CONSTRUCTION SUMMARY

33N - 3 - The Barossa 1 (S38-1) Elev A

Extras at Time of Sale

BAROSSA 1

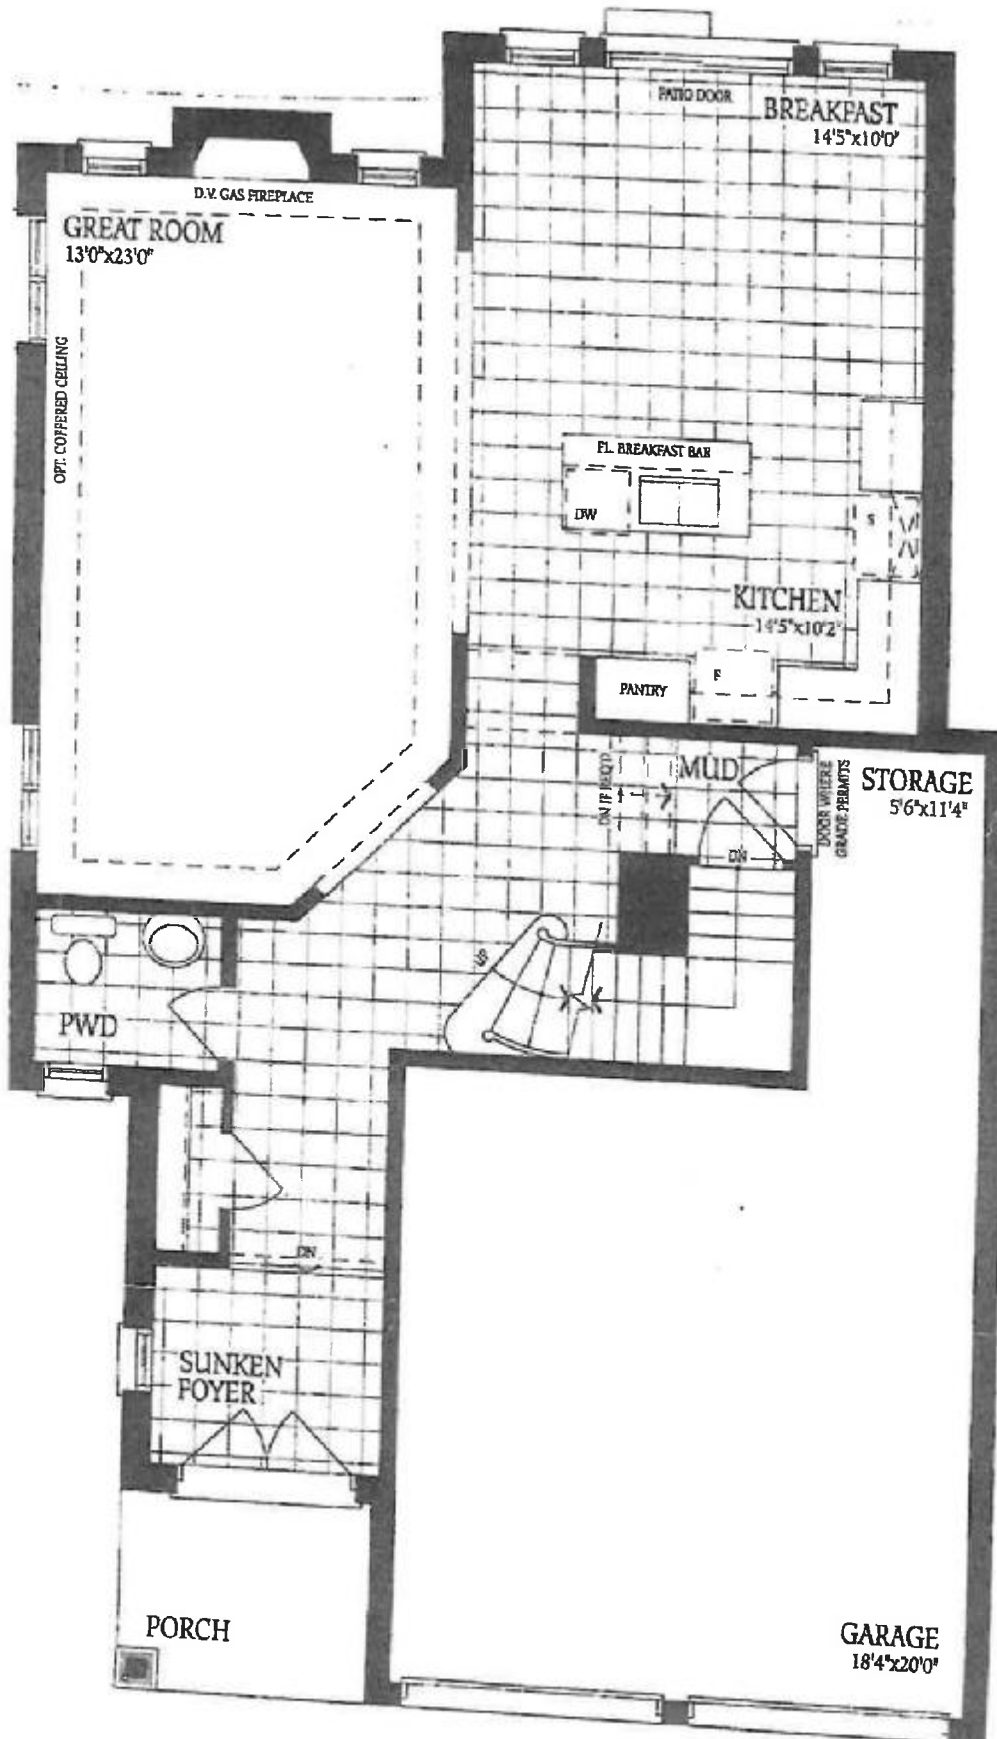
Inv.625	1 - REDESIGN MAIN BATH - AS PER SKETCH # 1 (1) CLOSE OFF DOOR FROM BEDROOM 4 TO BATH AND ADD ADDITIONAL SINK , 2) CLOSE OFF DOOR FROM BEDROOM 3 TO MAIN BATH AND ENLARGE BEDROOM 3 CLOSET - MAKE IT DOUBLE DOOR ,3) SHIFT MAIN BATH DOOR - AS PER SKETCH)
Line8072	Note:
24Nov21 / 22Mar22
